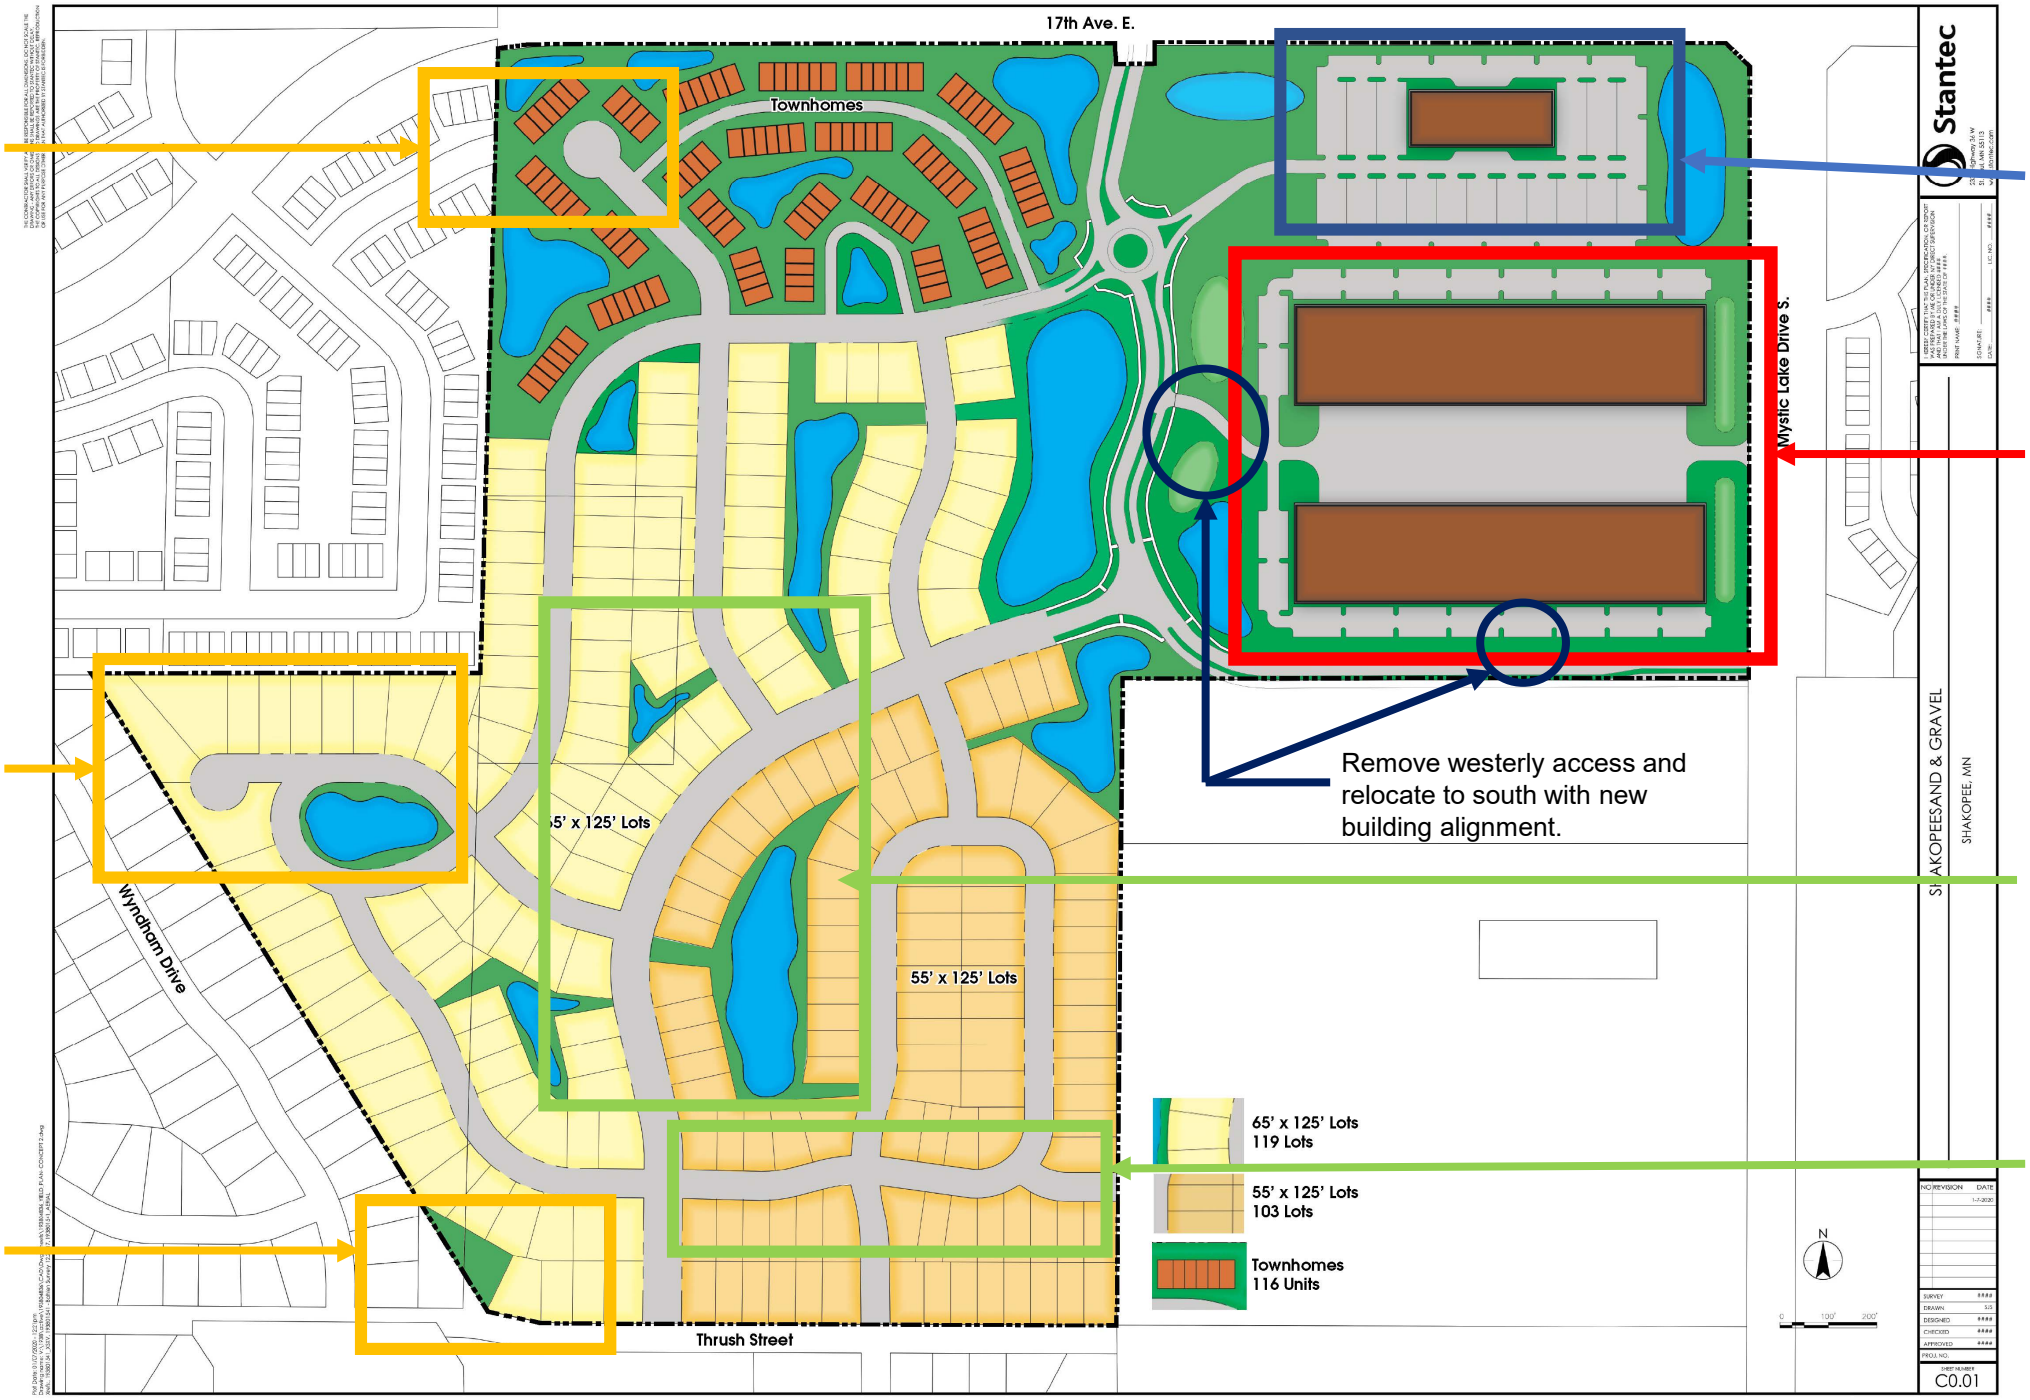
New streets should be connected to the existing street network.

Refigure lots, or revise as a trail corridor, including a trail connection to the west.

Refigure lots to incorporate the triangular parcel in the SW corner and eliminate open space behind residential lots (this should be done throughout the development).

Move building to the northeast corner, and consider using a L-shape design.

Access onto CSAH 83 is not allowed.

Rotate buildings 90 degrees so that the long side of the buildings are parallel with CSAH 83/Mystic Lake Drive.

Remove westerly access and relocate to south with new building alignment.

Incorporate a trail network system throughout the development.

Realign the road network into a 90 degree grid system.
